**REVISION 003 TO INVITATION  
TO TENDER**

<b>Title - Sujet :</b> Akamina Parkway Rehabilitation – Waterton Lakes National Park	
<b>Solicitation No. - N° de l'invitation :</b> 5P420-19-0205/A	<b>Date :</b> August 28, 2019
<b>Amendment No. - N° de modification :</b> 003	
<b>Client Reference No. - N° de référence du client :</b> 1519	
<b>GETS Reference No.   N° de référence de SEAG :</b> PW-19-00883617

### **Amendment 003**

This amendment is being raised to distribute information from the site visit and to answer to bidder questions.

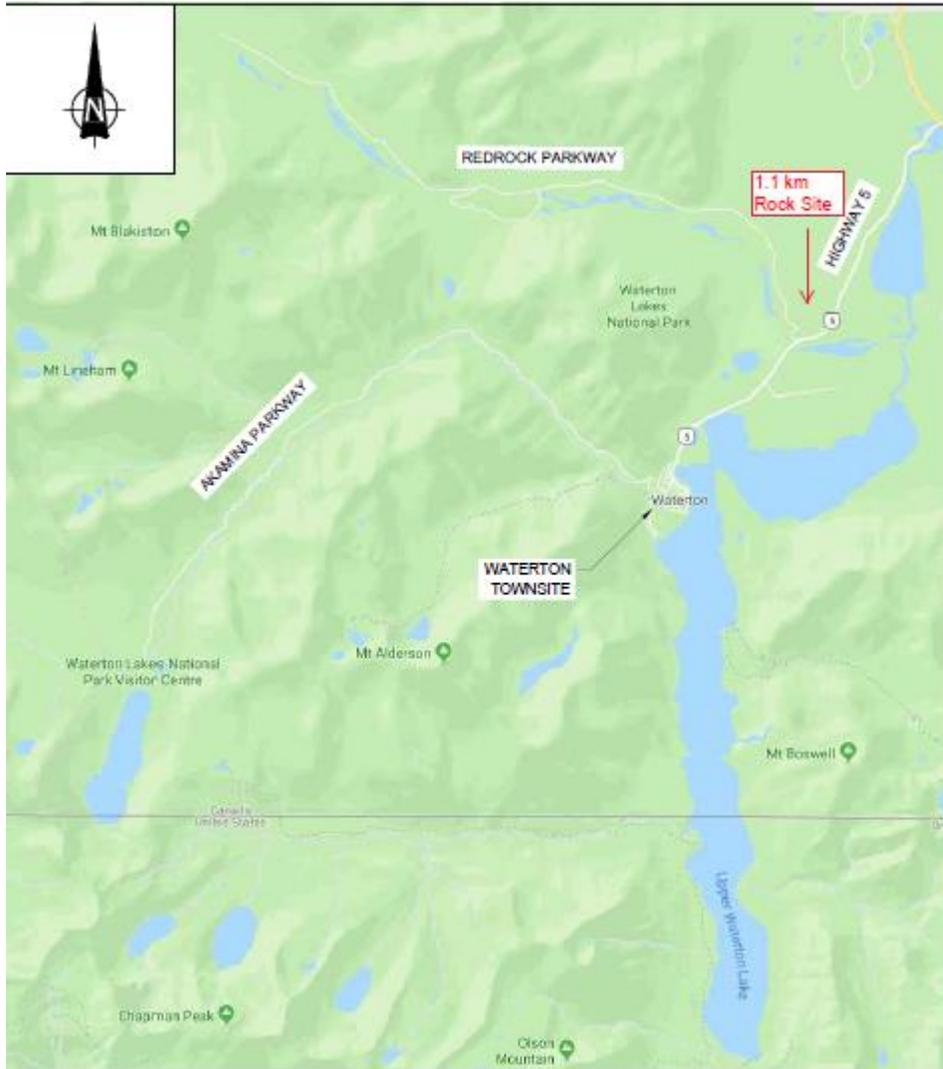
**Q57** Is there a potential location for rock disposal within the Park?

**A57** Boulders greater than 250 mm diameter from the Akamina Parkway may be stockpiled within the Park at and an active site 1.1 km from the Red Rock Parkway intersection with Highway 5. The dumped rocks must be managed and kept organized. Separation of rock into various size classifications will be paid under Section 01 21 00 Allowances.
